TECHNICAL BULLETIN - #A102
SUBJECT: #6120 MODULE W/CLOSING TIME DELAY
Effective Date: 7/26/01 Revised Date: 8/18/05

Figure 1

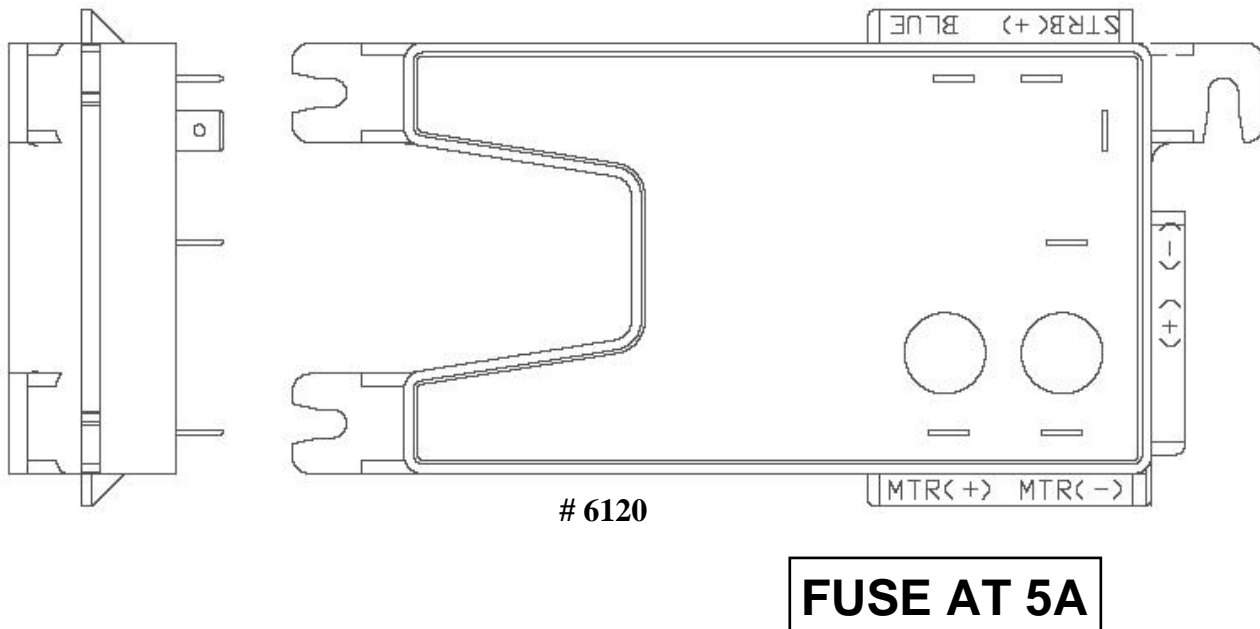
The 6120 Modules with date code GK1 and later (see Figure 1 for top & left-side views) incorporate a one second time delay between the closed shutdown point and the actual motor shutdown.

The purpose of this is to guarantee the attached Crossing Gate (X/G) or Stop Arm (S/A) on the 6- Series units are properly nested against the stop fixture when mounted on a vehicle.

This means that operation of 6- Series unit without an attached X/G, S/A or complete top to bottom hinge assembly will possibly result in the hinge arm continuing to turn past the normal closure point and/or to oscillate at the ~ -90° position. If this happens, disconnect the power and manually swing the hinge arm to within the normal operating range before proceeding with the unit's installation or test.

When connecting power source, make sure it is fused at 5 amps.
